NOTICE OF
CHANGE

MIL-STD-883E
NOTICE 3
5 November 1999

TEST METHOD STANDARD
MICROCIRCUITS

1. THE FOLLOWING TEST METHODS OF MIL-STD-883E HAVE BEEN REVISED AND SUPERSEDE THE TEST METHODS LISTED:

FIGURE 2032-3h. Class H metallization void criteria.

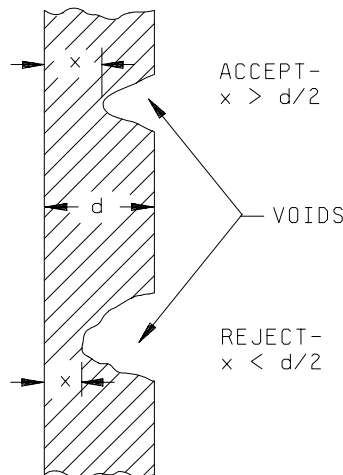
- * 3.1.1.1 c. Scratch that completely crosses a metallization path and damages the surface of the surrounding passivation, glassivation, or substrate on either side.
- d. Scratches or probe marks in the bonding pad area that expose underlying material over greater than 25 percent of the original unglassivated metallization area.
- e. For capacitors only, a scratch in the metallization, other than in the bonding pad area, that exposes the dielectric material.
- 3.1.1.2 Metallization voids.
- a. Void(s) in the metallization, excluding bonding pads, that leaves less than 50 percent of the original metallization width undisturbed (see figure 2032-3h).

* FIGURE 2032-28h. Class H resistor loop nicking and scorching criteria exceptions.

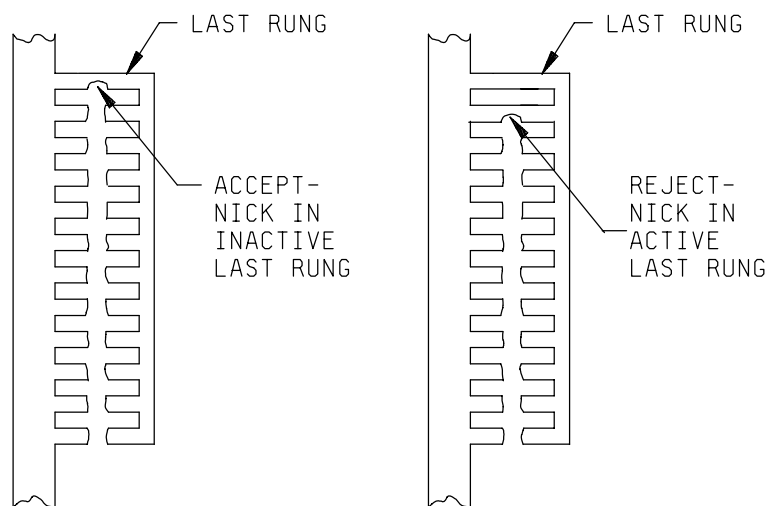
NOTE: This criteria does not apply to the second rung of a resistor loop since the second rung is inactive. This criteria does not apply to a fine loop or to a resistor structure that is comprised of fine loops (see figure 2032-28h).

NOTE: See 3.i.(35) for a definition of coarse and fine resistor loop structures. The element drawing must be referenced to determine if a given resistor loop structure is coarse or fine.

FIGURE 2032-30h. Class H resistor ladder sidebar trim criterion.

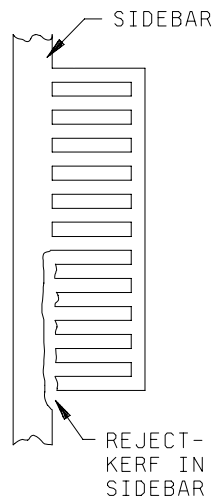
- 3.1.7 d. (Continued.)
NOTE: This criterion does not apply to the last rung of a resistor ladder if the last rung is inactive (see figure 2032-29h).

- e. A kerf or scorch which extends into a resistor ladder sidebar (see figure 2032-30h).
e. Same as class H.
